Rewritten by Gabe

Sheet: /IMU/
 File: MP6050.sch

Title: MP6050 Breakout Board

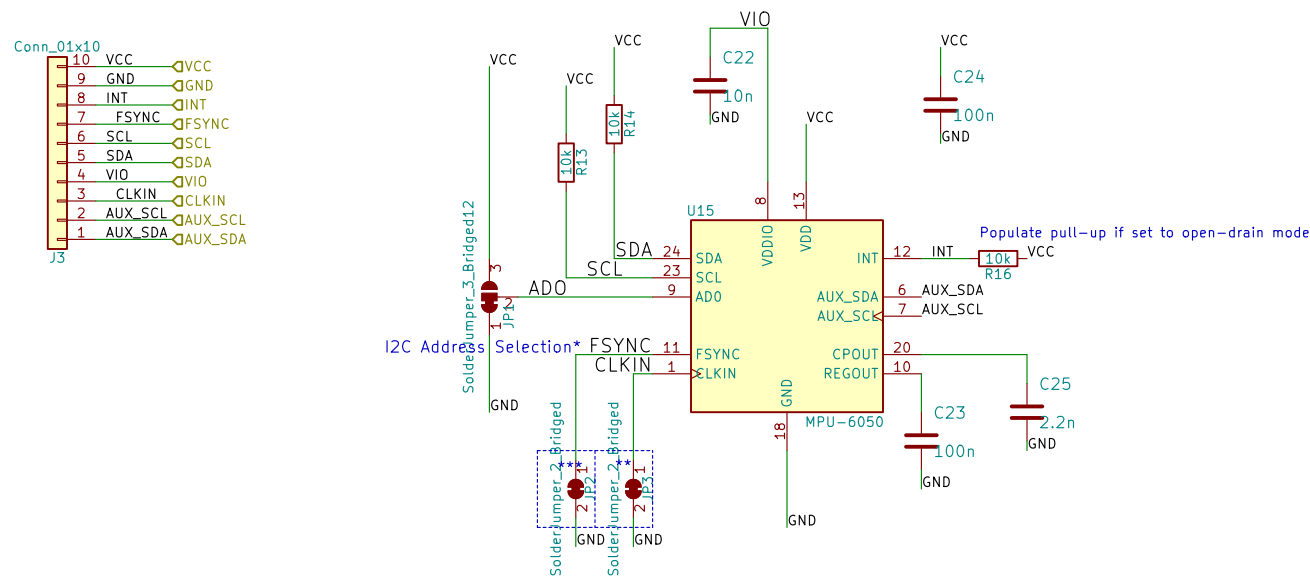
Changes to V11.....
 SCL and SDA were switched on V10, fixed on V11
 Broke out VLOGIC line
 C2 was mislabeled as 10nF, should have been 2.2nF.
 Added selectable jumpers to CLK, FSYNC and ADO
 Minor layout changes
 Played around with IC footprint.
 Added 4 small tcream squares to middle pad.
 Rounded and elongated pads.

BOM changes....
 YES
 C2 is now 2.2nF instead of 10nF

New Stencil.....
 YES

Changes to V12:
 -0402 --> 0603
 -Changed Z-Axis symbol to reflect proper orientation from circle with x to circle with dot
 -Changed NET labels in schematic to flags
